# City of Mississauga Department Comments

Date Finalized: 2023-11-29	File(s): A461.23 Ward: 4
To: Committee of Adjustment	
From: Committee of Adjustment Coordinator	Meeting date:2023-12-07 1:00:00 PM

**Property Address:** 4506 Mayflower Drive

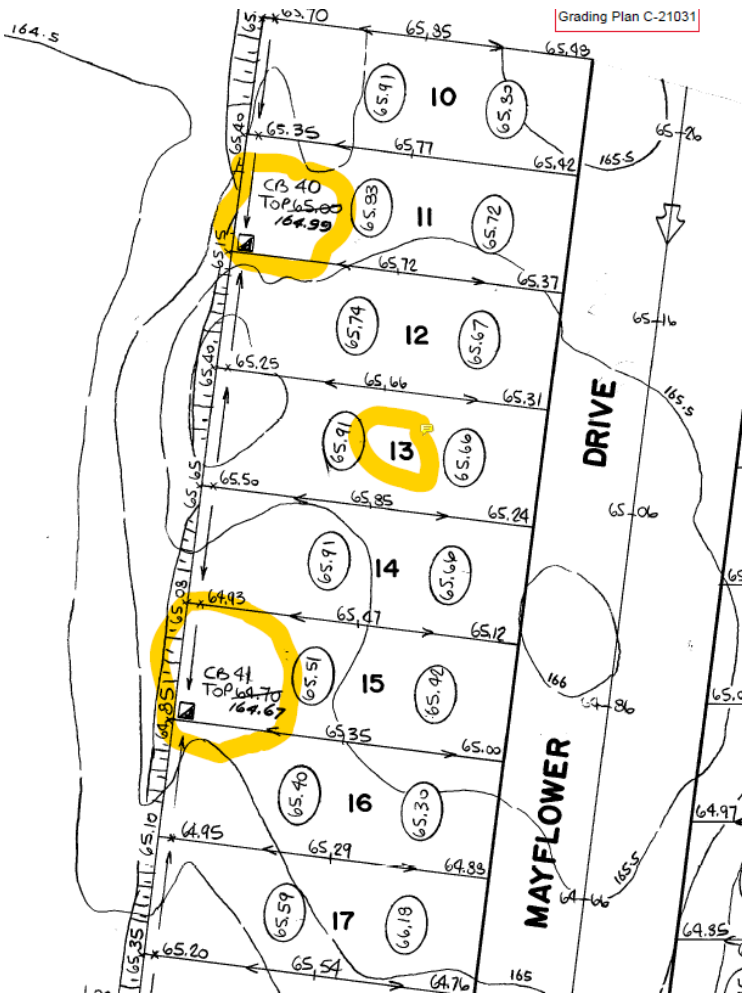
We have attached a copy of Grading Plan C-21031 and highlighted the subject Lot #13. The Grading Plan indicates that the drainage pattern for this lot was designed such that drainage from the rear yard was to be directed onto the abutting Lot #14 and then into a catch basin located at the rear of Lot #15.

**Aerial Photo for 4506 Mayflower Drive****Appendix 2 – Zoning Comments**

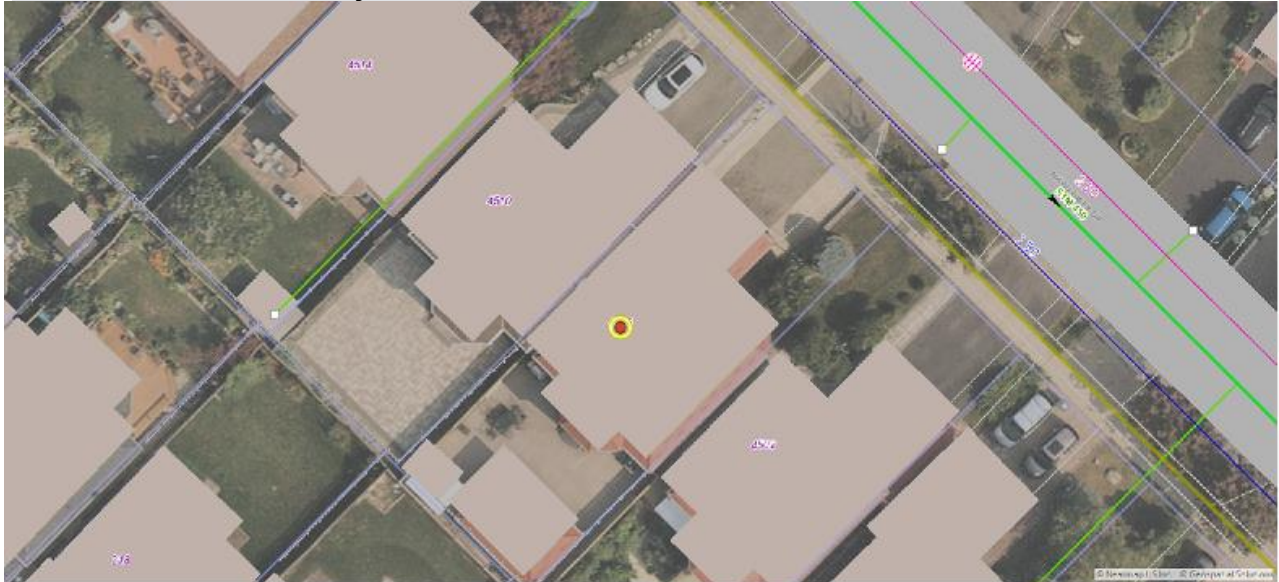
Also attached an aerial photo depicting the subject and abutting property which clearly indicates that the abutting property has also constructed a hard surface area in their entire rear yard which likely has impacted the drainage pattern.
